Ocean Park Master Redevelopment Project
Contractor No. CI05 – Site Formation, Funicular Tunnel and
Miscellaneous Works
Environmental Monitoring Works (Terrestrial Ecology)
Plant Transplantation Method
August 2007
(Doc. No. OPE/DBJV/PROJ/QSE/0078/D)

Transplantation Proposal for Uncommon Plant Species

2. I have the following comments on the Transplantation Proposal for Uncommon Plant Species (Rev. C):

Contractor's Submission Reference No.				OPE/DBJV/CSF/20053/C – Plant Transplantation Proposal [June 2007]		For MCAL Use		
Item No	Review By	Document / Drawing Reference	Reply Code	PMR's Comments	DBJV's Response	Action	Action Date	Closed Date
1	AFCD	RTC Item 5(ii)		According to the draft proposal submitted in November 2006, the survey conducted in August 2006 covered the flowering periods of Long Tentacle Orchid (flowers in August) and Green-flowered Rattlesnake-Plantain (flowers between August and November). Besides Sword-leaved Orchid and Chinese Lily, please review if the individuals of these two plant species found in August 2006 would be affected by the works and requiring transplanting.	Noted. During the time of response to comment, an additional survey was undertaken to search

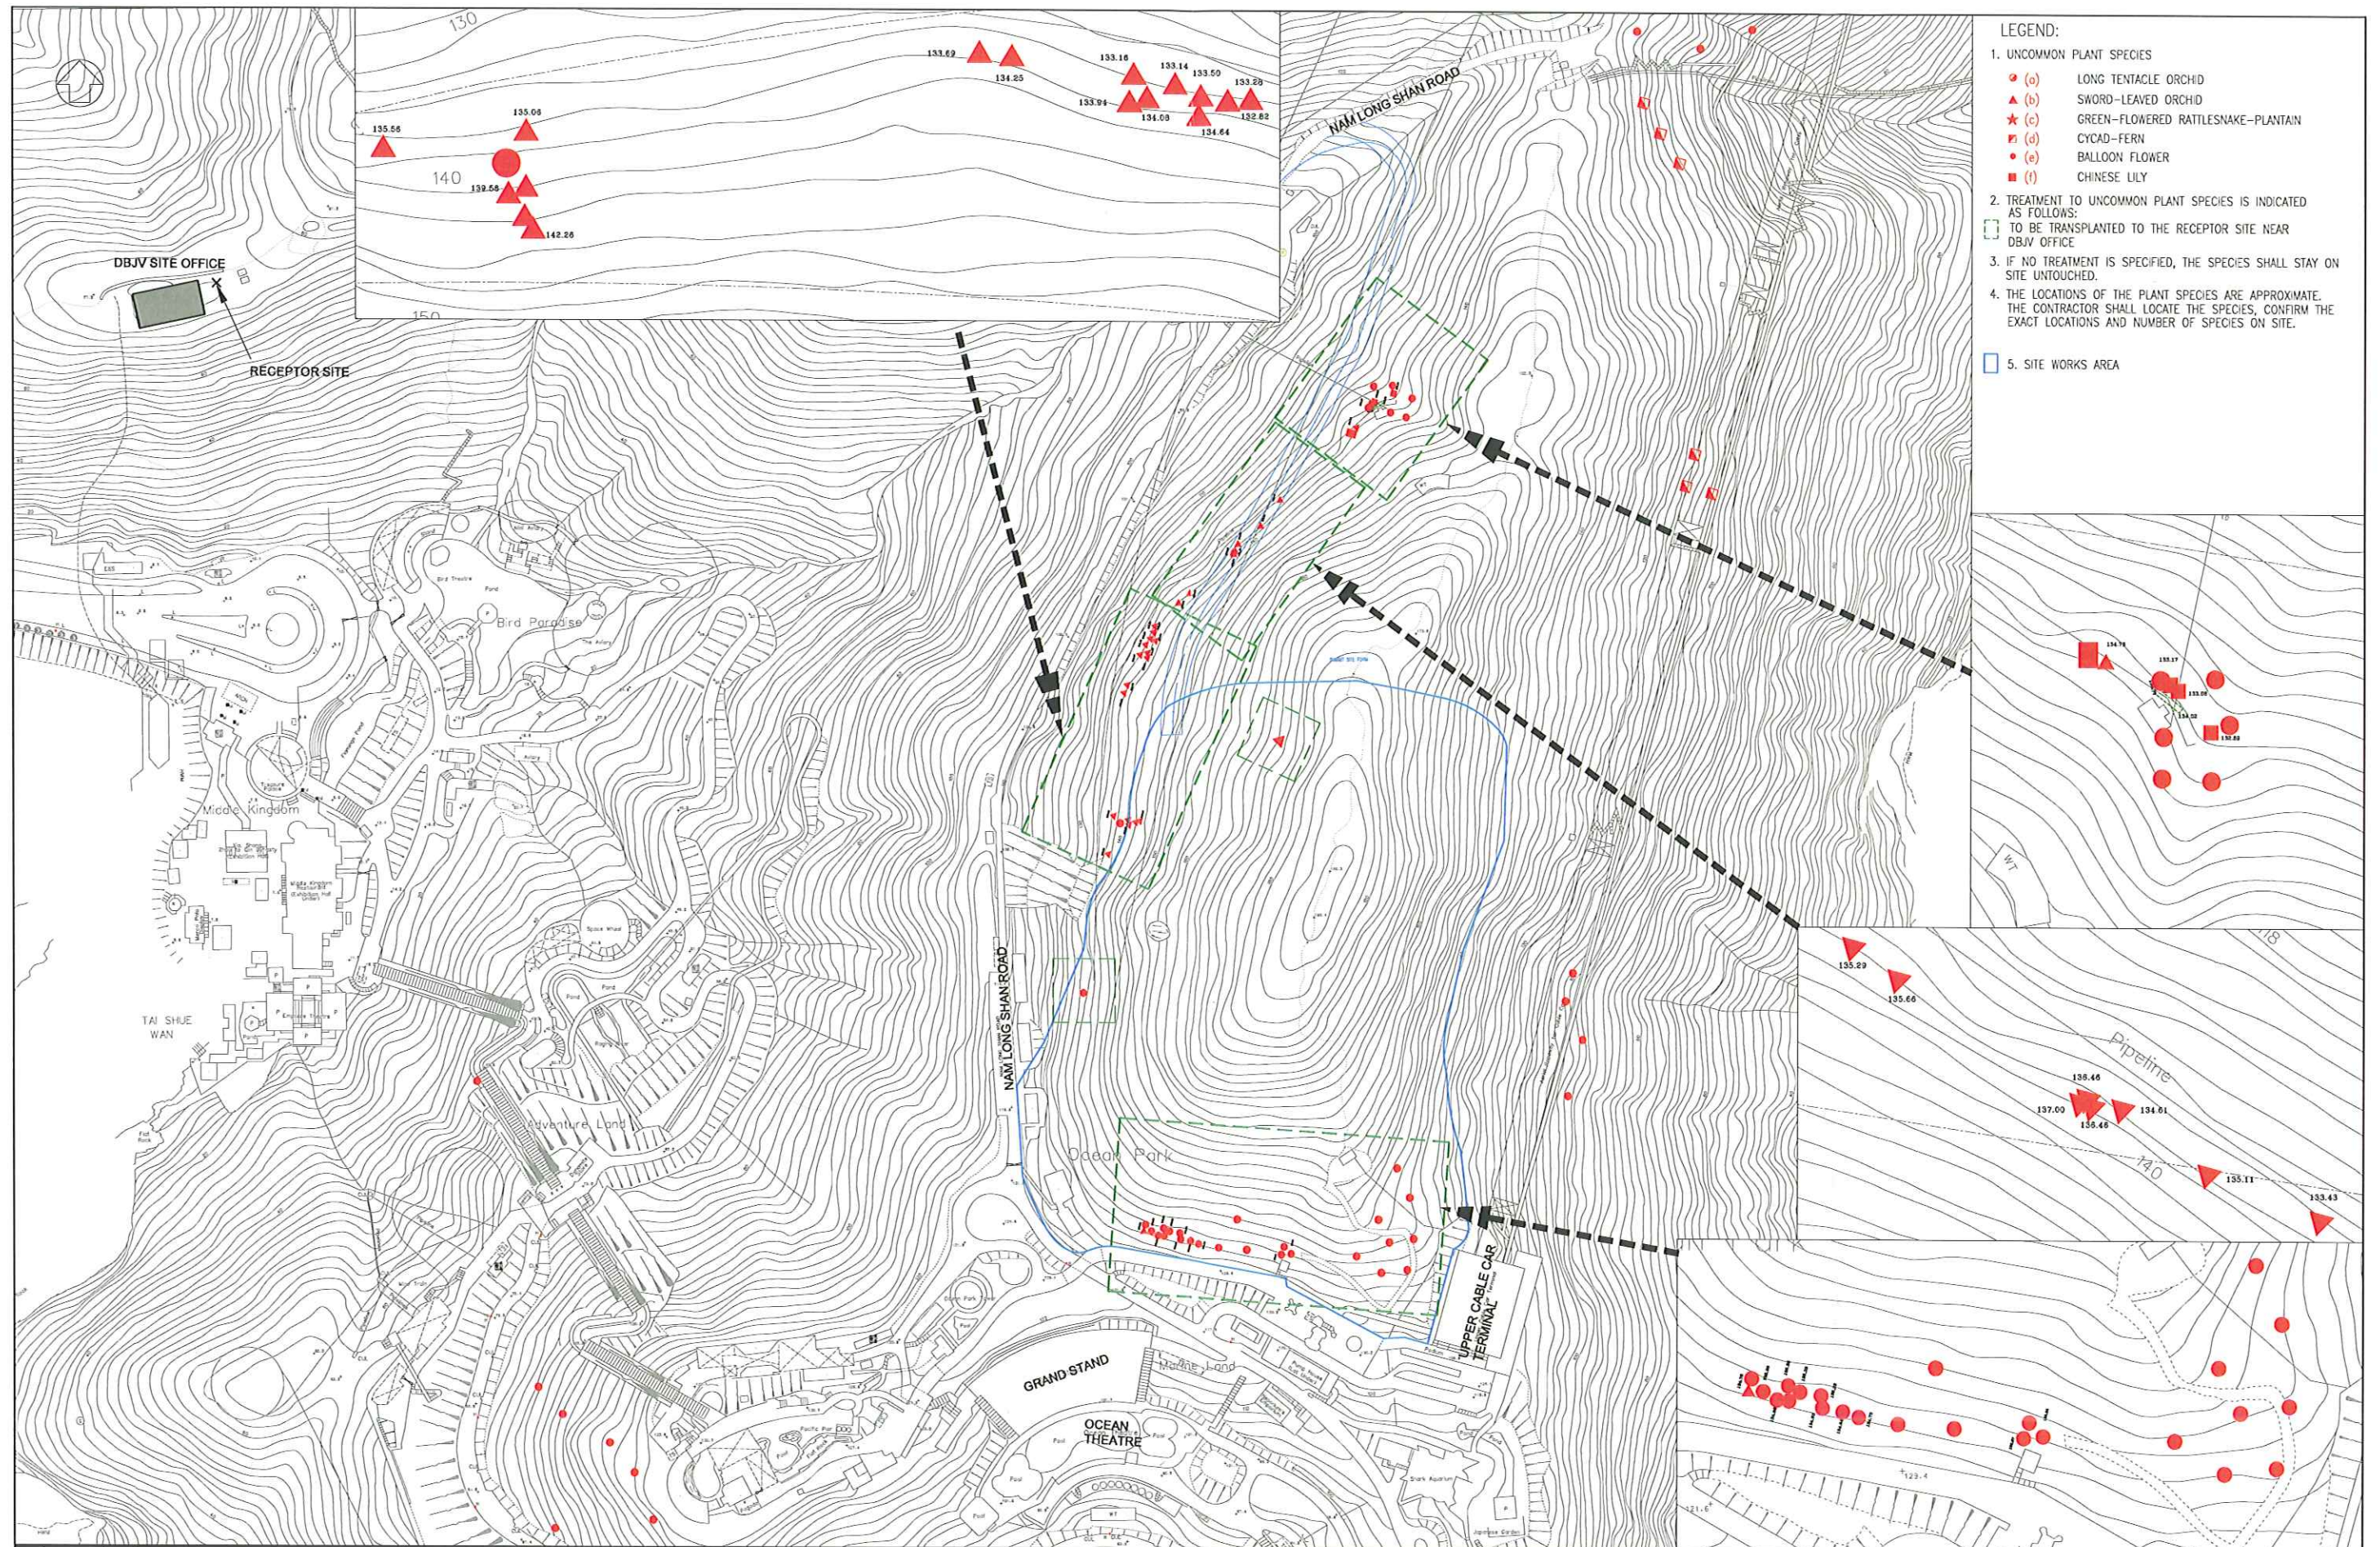
(a) If only the individuals of plant species marked (T) in Figure 1 Layout Plan for Uncommon Species would be transplanted, only 33 nos. of them would be transplanted based on the plan. It is unclear which individual is marked (T) for a group of plants e.g. the group to the north of 'Grand Stand' with 25 nos. of identified plant individuals but only 16 nos. of (T) were marked. According to Table 1 under para. 2.4 of the proposal, it seems that all the individuals (100 nos.) of 3 uncommon plant species identified would be transplanted. If not all identified individuals would be transplanted, please clarify which one and why they would be transplanted but not the others. Figure 1 should be revised to present the picture clearly.

- (b) It is stated that only the individuals within the works areas would be transplanted. If the blue lines indicate the extent of the works area, it is noted from Figure 1 that some identified plant individuals outside the boundary of the works area would still need to be transplanted. Please clarify.

If the purpose of this figure is to show the findings of the survey in February 2007, indication of the Cycad-fern is misleading as none was found during the survey.

Contractor's Submission Reference No.				OPE/DBJV/CSF/20053/C – Plant Transplantation Proposal [June 2007]		For MCAL Use		
Item No	Review By	Document / Drawing Reference	Reply Code	PMR's Comments	DBJV's Response	Action	Action Date	Closed Date
3	AFCD	RTC Item 6		(a) If only the individuals of plant species marked (T) in Figure 1 Layout Plan for Uncommon Species would be transplanted, only 33 nos. of them would be transplanted based on the plan. It is unclear which individual is marked (T) for a group of plants e.g. the group to the north of 'Grand Stand' with 25 nos. of identified plant individuals but only 16 nos. of (T) were marked. According to Table 1 under para. 2.4 of the proposal, it seems that all the individuals (100 nos.) of 3 uncommon plant species identified would be transplanted. If not all identified individuals would be transplanted, please clarify which one and why they would be transplanted but not the others. Figure 1 should be revised to present the picture clearly. (b) It is stated that only the individuals within the works areas would be transplanted. If the blue lines indicate the extent of the works area, it is noted from Figure 1 that some identified plant individuals outside the boundary of the works area would still need to be transplanted. Please clarify.	Noted. Figure 1 would be updated to make all information clearly.

9	AFCD	Para. 4.4.3, line 2		Please revise 'plant heath condition' to read 'plant health condition'.	Noted. The text would be amended accordingly.			
10	AFCD	Figure 1 Layout Plan for Uncommon Species		If the purpose of this figure is to show the findings of the survey in February 2007, indication of the Cycad-fern is misleading as none was found during the survey.	Noted. Figure 1 would be updated to make all information clearly.
